Site Instruction

SI 24

PROJECT : Hampton Manor
PROJECT No : 1136.13
DATE : August 14, 2018

Title: Removal of Insulation behind Precast

Section Details
as noted A652

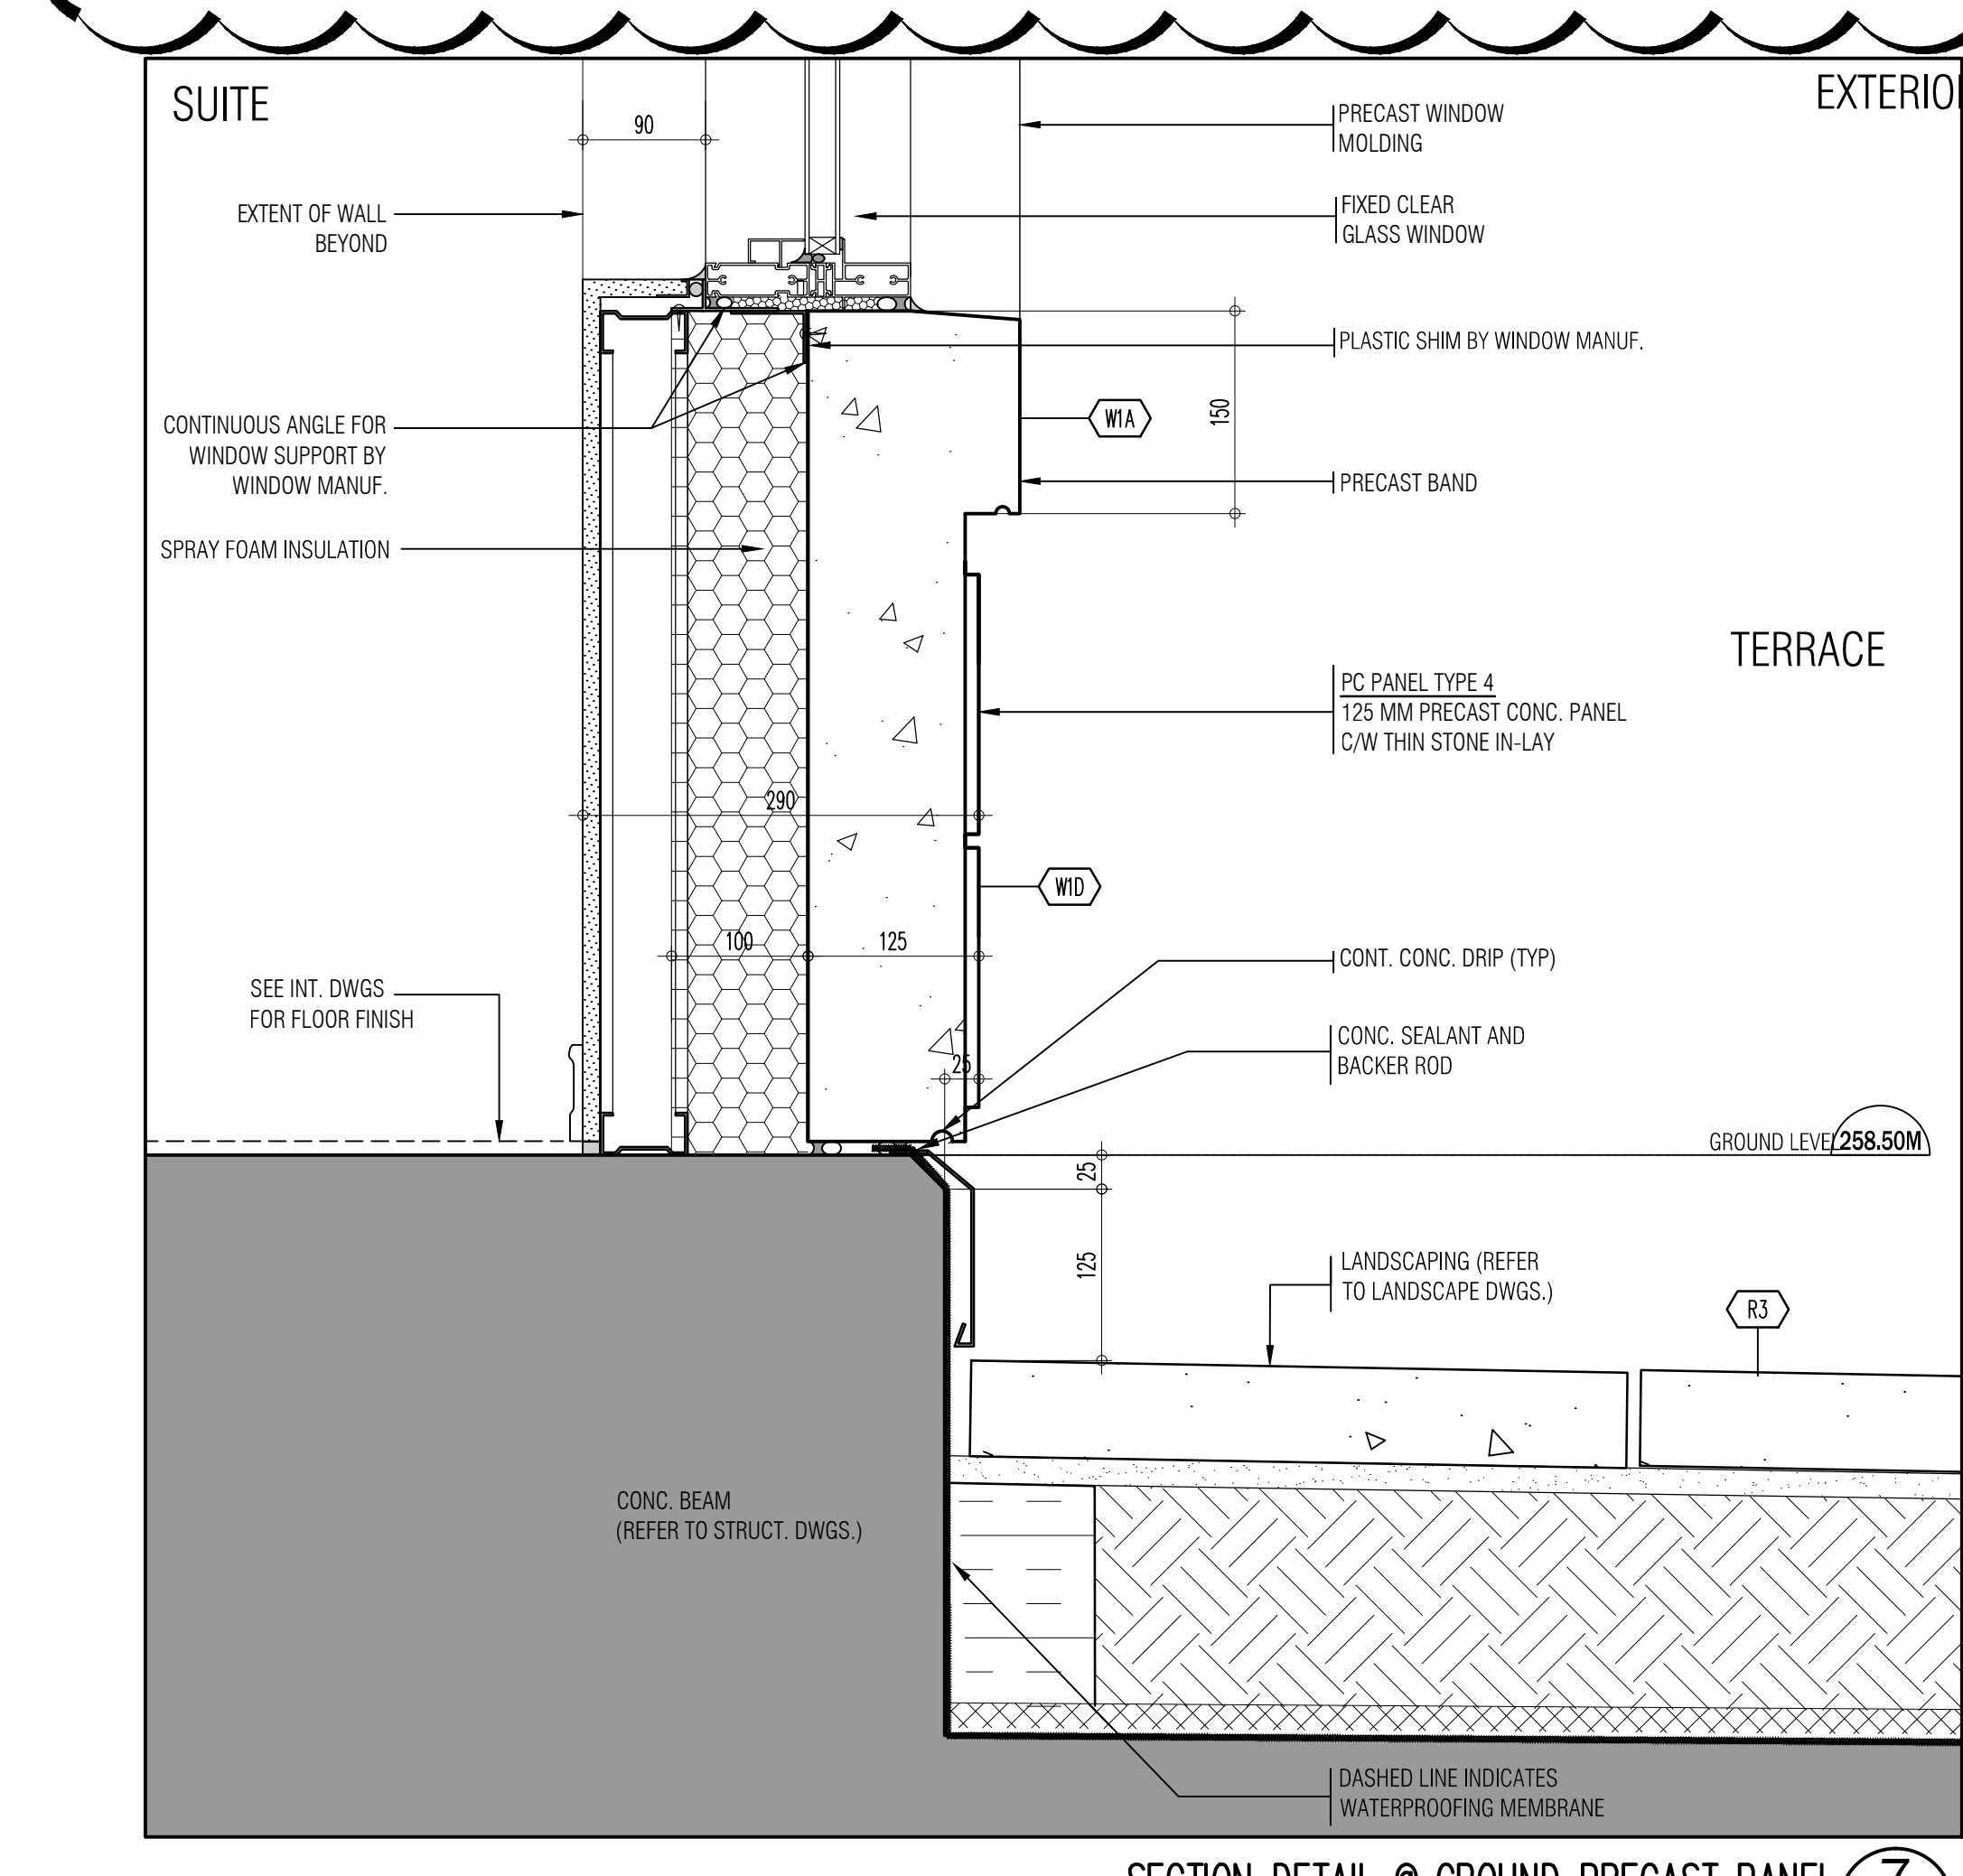
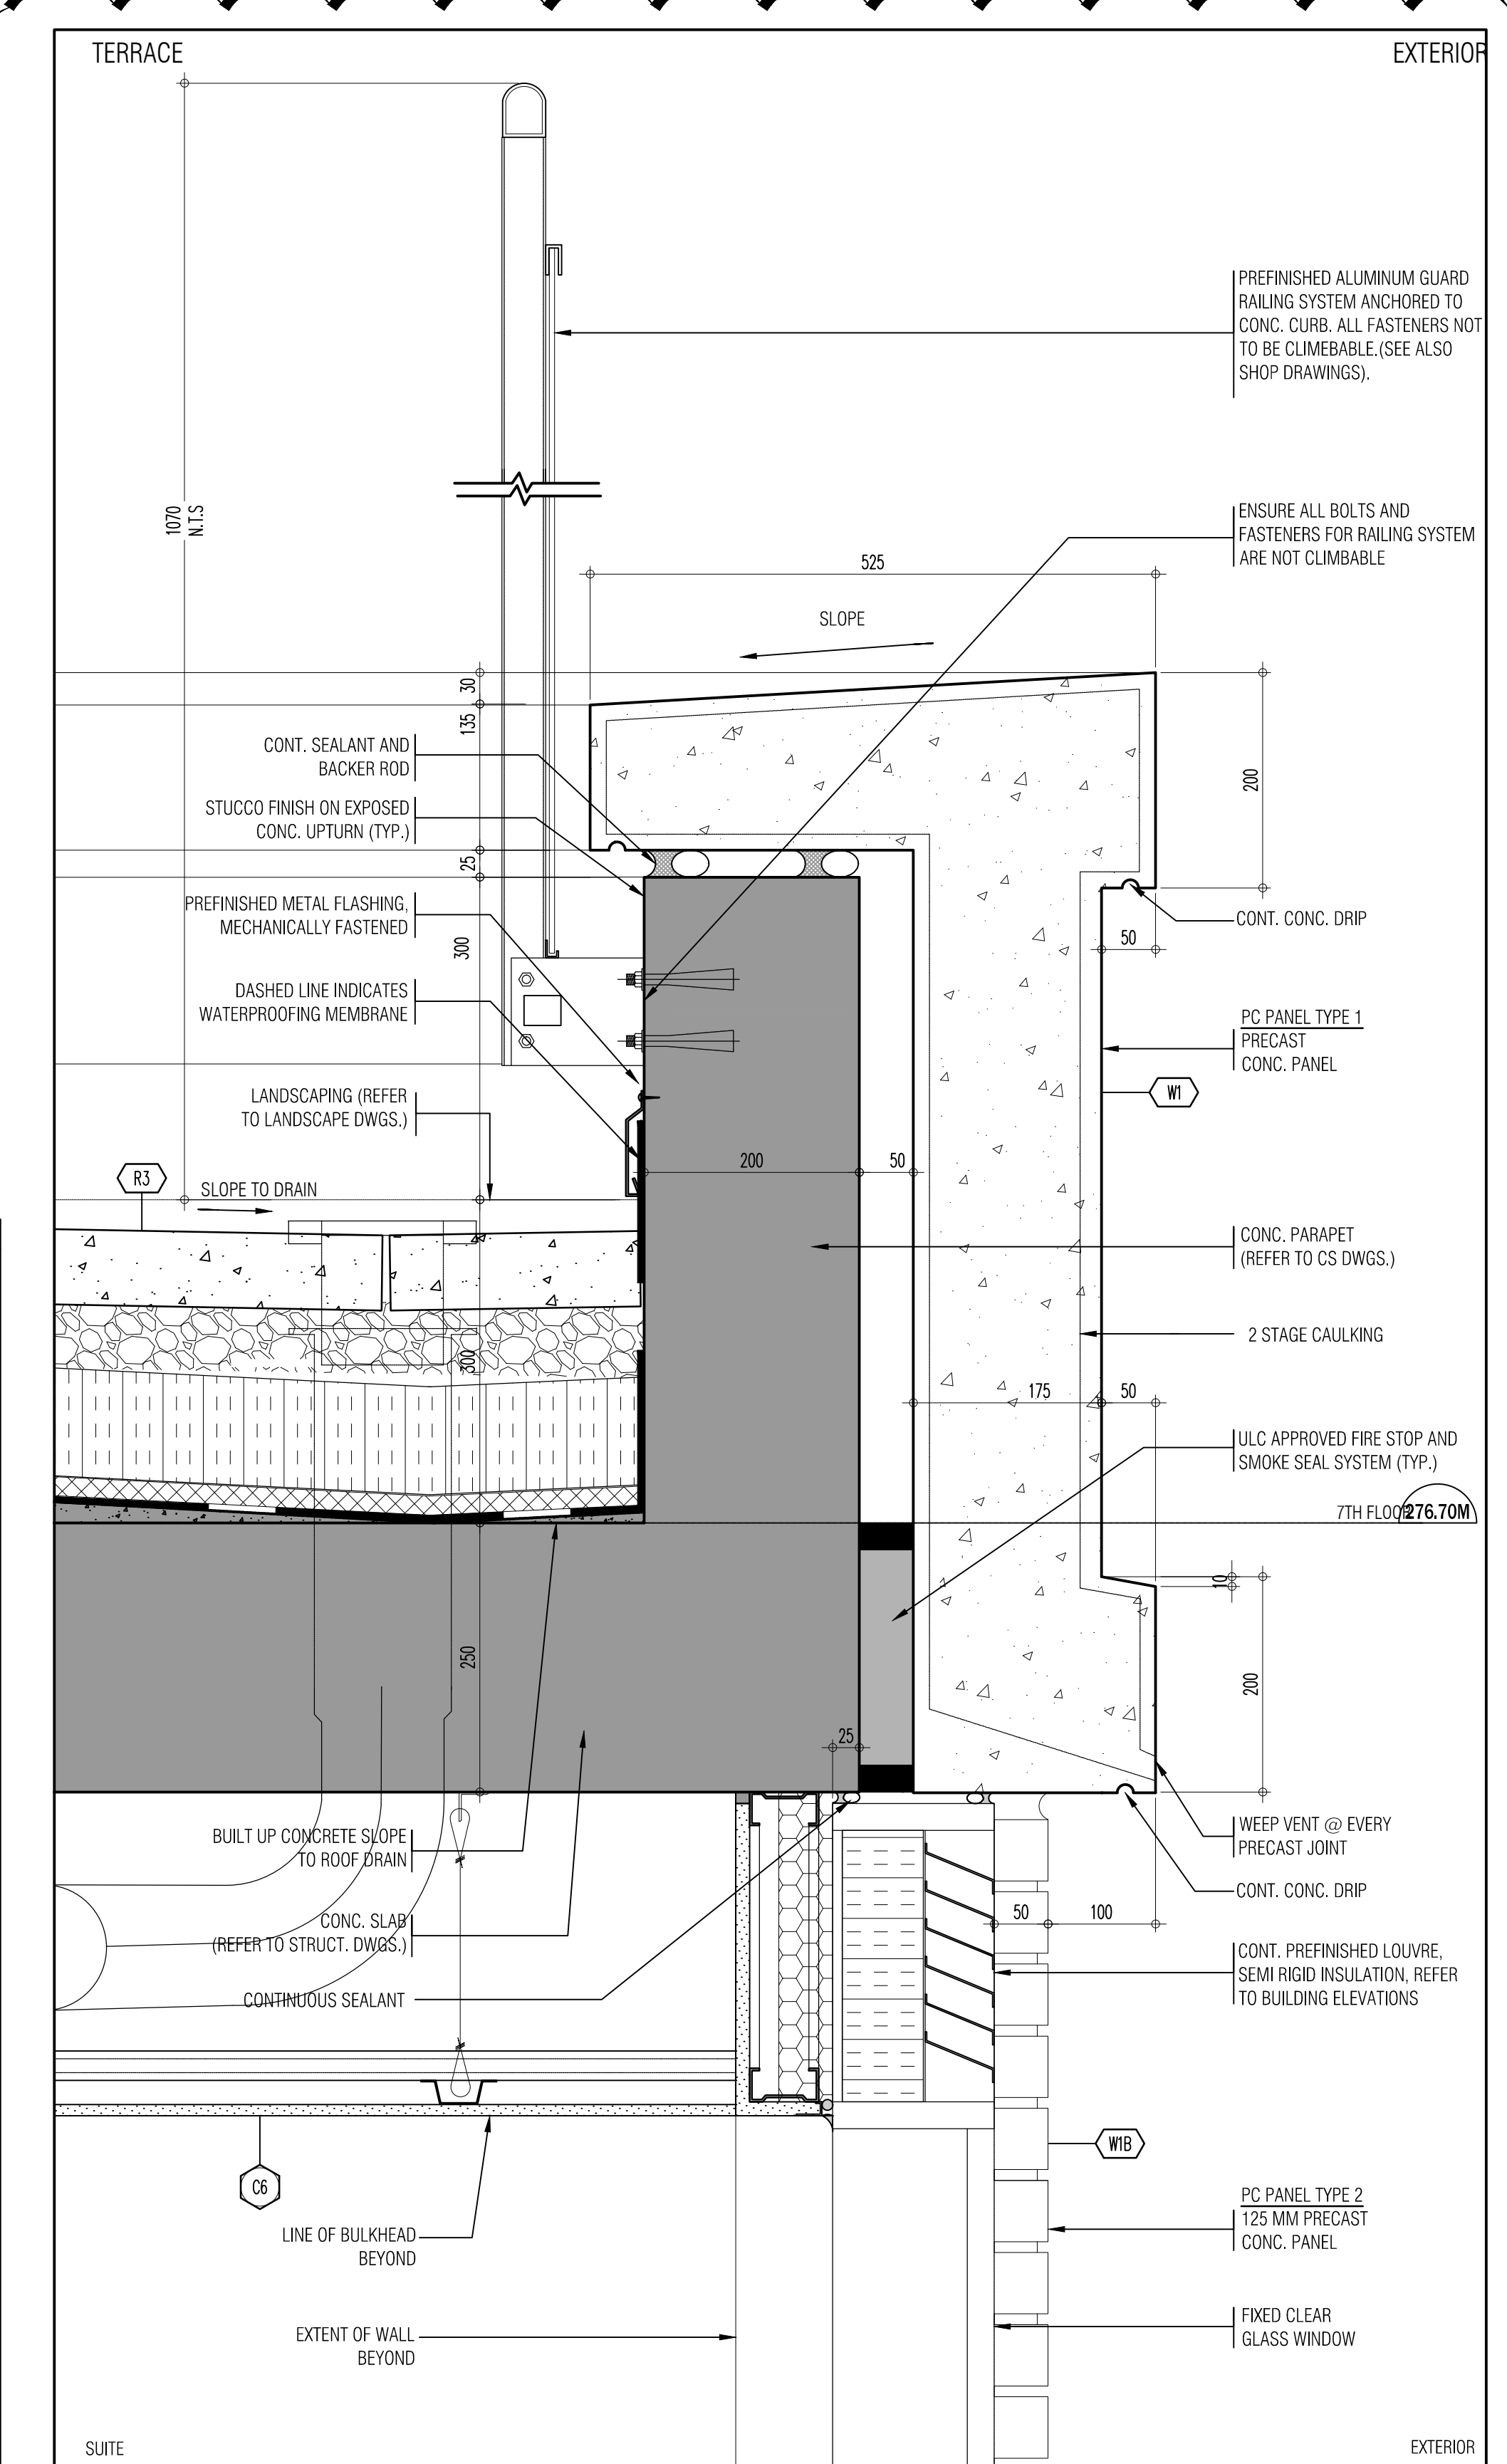
- Removal of insulation behind precast at terraces and roof.
